[State Clearinghouse No. 2008121080]

## **Los Angeles International Airport (LAX) Bradley West Project**

## **Responses to Comments and Corrections and Additions to the Draft EIR**

Figure 4.2-5b

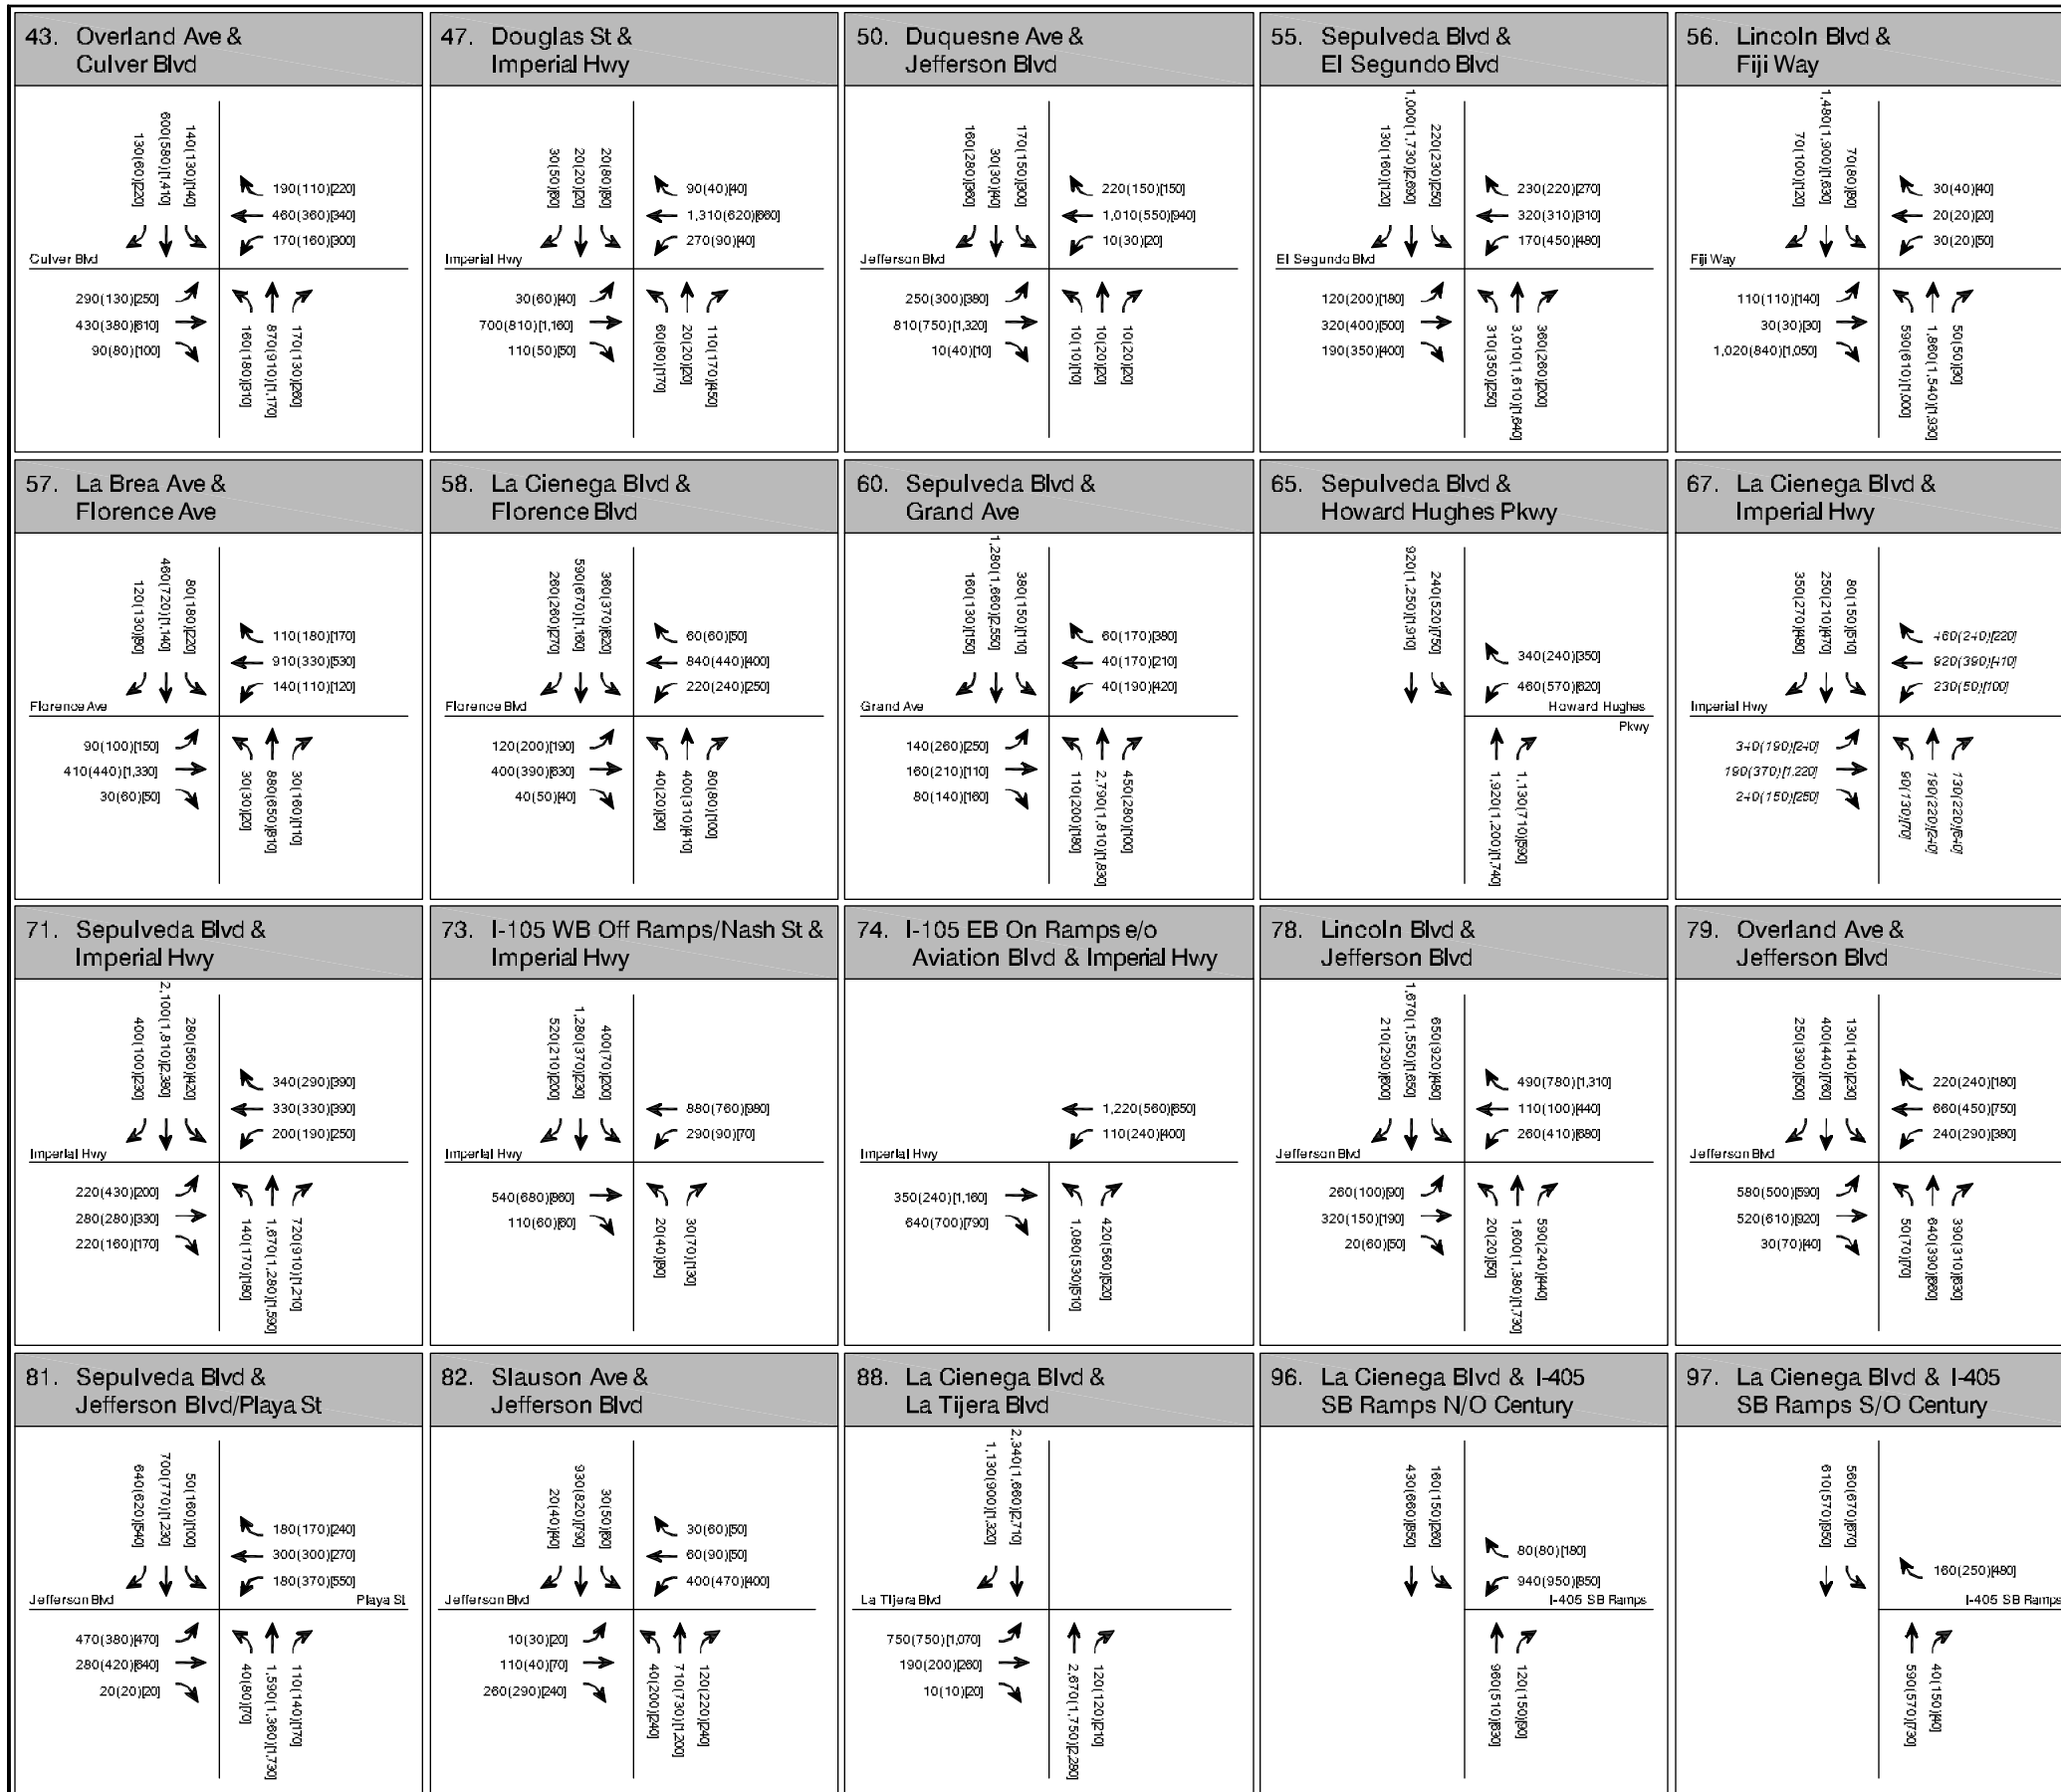
**Comment:** Volume 4, Appendix C-5, page 4, La Cienega Boulevard and Imperial Highway (Intersection # 67): The AM peak vehicle counts for Existing Conditions do not match those shown in Volume 1 (Main Document), Figure 4.2-3b; similar errors occur with the Mid-day and PM peak vehicle counts. All intersection capacity analysis effected by these errors should be revised accordingly and corresponding mitigation measures and potential improvements should be identified and evaluated for any anticipated significant impacts. If similar errors occur for other project scenarios (e.g. "No Project," "Plus Project" etc.) then capacity analysis calculations and any resulting potential mitigation measures should be also revised accordingly.

**Response:** The typographical error is noted. In response, Figure 4.2-3b on page 4-105, Figure 4.2-4b on page 4-139, and Figure 4.2-5b on page 4-147 of the Bradley West Project Draft EIR have been revised. Please see Chapter 3, Corrections and Additions to the Bradley West Project Draft EIR. The intersection capacity analyses under all scenarios are not affected by this typographical error as it only occurred in the figures. The correct values were used in the LOS calculations and hence no revisions to the LOS calculations are required.

**LAX Bradley West Project Draft EIR** **Future-Adjusted (2013) Without Project Traffic Volumes** **Figure 4.2-5c**

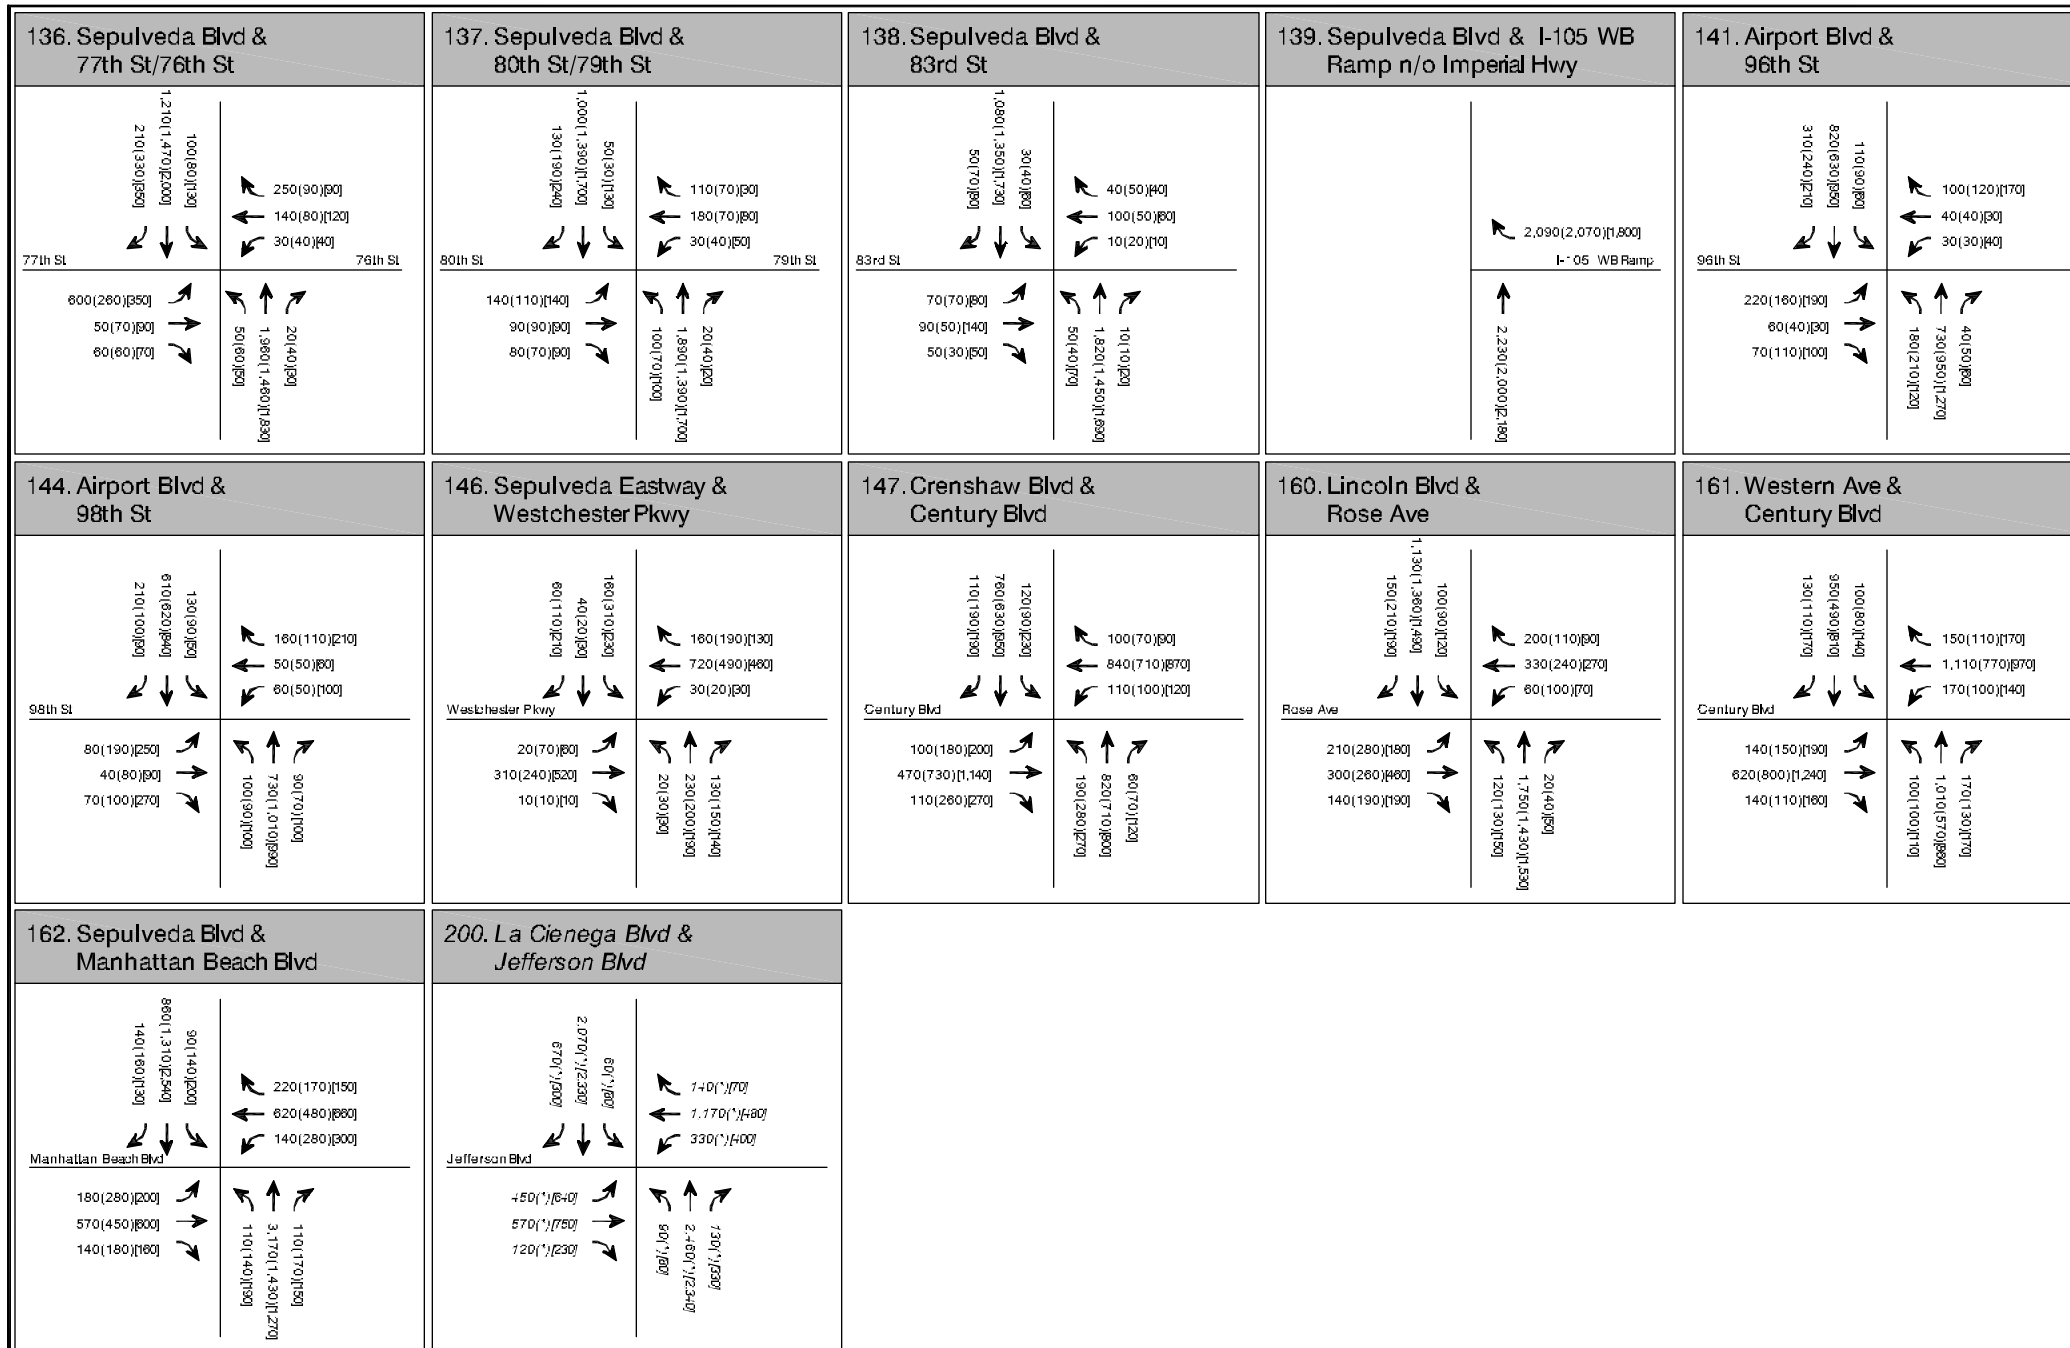
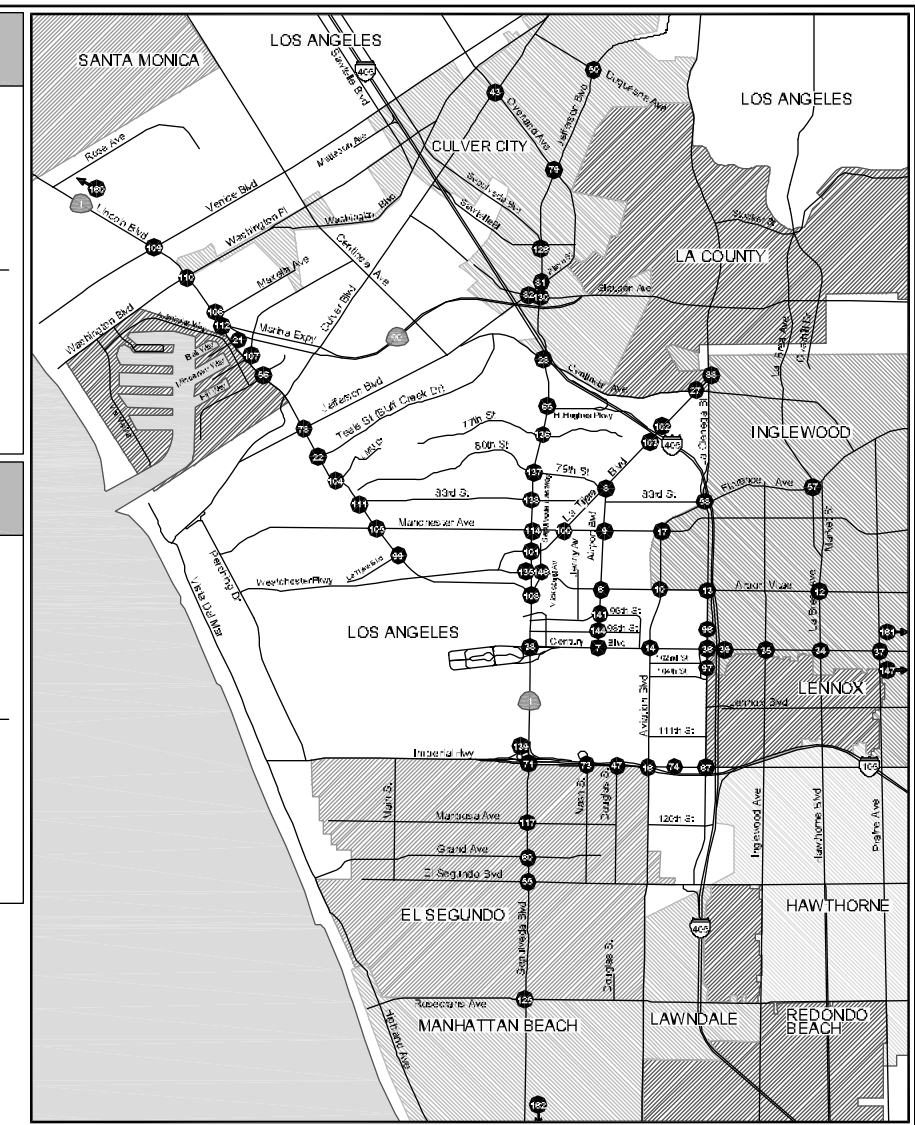
**Comment:** Volume 4, Appendix C-5, page 9, Lincoln Boulevard and Washington Boulevard (Intersection # 110): The AM peak vehicle counts for Existing Conditions do not match those shown in Volume 1, Figure 4.2-3c; similar errors occur with the Mid-day and PM peak vehicle counts. All intersection capacity analysis effected by these errors should be revised accordingly and corresponding mitigation measures and potential improvements should be identified and evaluated for any anticipated significant impacts. If similar errors occur for other project scenarios (e.g. "No Project," "Plus Project" etc.) then capacity analysis calculations and any resulting potential mitigation measures should also be revised accordingly.

**Comment:** Volume 4, Appendix C-5, page 9, Lincoln Boulevard and 83rd Street (Intersection #111): The AM peak vehicle counts for Existing Conditions do not match those shown in Volume 1, Figure 4.2-3c; similar errors occur with the Mid-day and PM peak vehicle counts. All intersection capacity analysis effected by these errors should be revised accordingly and corresponding mitigation measures and potential improvements should be identified and evaluated for any anticipated significant impacts. If similar errors occur for other project scenarios (e.g. "No Project," "Plus Project" etc.) then capacity analysis calculations and any resulting potential mitigation measures should also be revised accordingly.

**Response:** The typographical error is noted. In response, the volume figure for the Lincoln Boulevard and Washington Boulevard intersection in Figure 4.2-3c on page 4-107, Figure 4.2-4c on page 4-141, and Figure 4.2-5c on page 4-149 of the Bradley West Project Draft EIR has been revised. Please see Chapter 3, Corrections and Additions to the Bradley West Project Draft EIR. However, the revised Mid-day southbound through volume at the Lincoln Boulevard and Washington Boulevard intersection does not match the vehicle counts because the volume was adjusted to be consistent with the traffic volumes at nearby intersections. As stated on page 4-90 in Section 4.2 of the Bradley West Project Draft EIR, traffic volumes, counted or forecasted, are balanced to ensure a reasonable amount of vehicles are either gained or lost between adjacent intersections. The volumes used in the intersection analysis for all scenarios match the revised volumes for all periods; therefore, the intersection analysis is not affected and no additional revisions are required.

**Response:** The typographical error is noted. In response, the volume figure for the Lincoln Boulevard and 83rd Street intersection in Figure 4.2-3c on page 4-107, Figure 4.2-4c on page 4-141, and Figure 4.2-5c on page 4-149 of the Bradley West Project Draft EIR has been revised. Please see Chapter 3, Corrections and Additions to the Bradley West Project Draft EIR. However, the revised AM and Mid-day northbound and southbound through volumes at the Lincoln Boulevard and 83rd Street intersection do not match the vehicle counts because the volume was adjusted to be consistent with the traffic volumes at nearby intersections. As stated on page 4-90 in Section 4.2 of the Bradley West Project Draft EIR, traffic volumes, counted or forecasted, are balanced to ensure a reasonable amount of vehicles are either gained or lost between adjacent intersections. The volumes used in the intersection analysis for all scenarios match the revised volumes for all periods; therefore, the intersection analysis is not affected and no additional revisions are required.
